Comments on Scoping Report on proposed Wind Energy Facility near Caledon.

Re: Draft Environmental Impact Assessment Report for the Proposed Caledon Wind Farm

DEA ref: 12/12/20/1701

COMMENT ON DRAFT EIA REPORT

Figure 4: Proposed wind farm development in the Caledon and Botrivier area. The current study is reflected in portions of the mauve area.

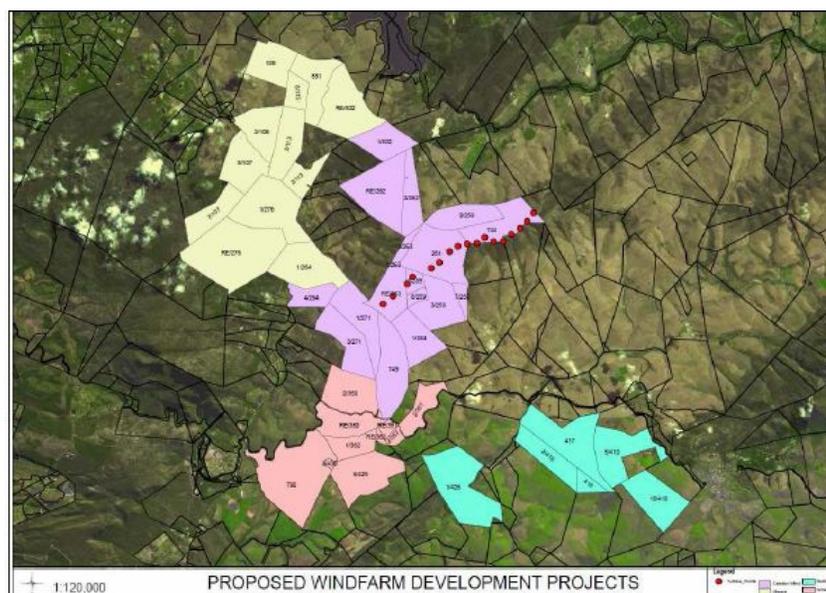
We are much concerned about the potentially huge cumulative environmental impacts of this development along with the recently authorized Biotherm project, and what we are now advised are two other large wind farm developments directly abutting on this one. We have sought further details about these new projects from the DEA. See Fig. 24 in the Visual Impact Report. Also below:
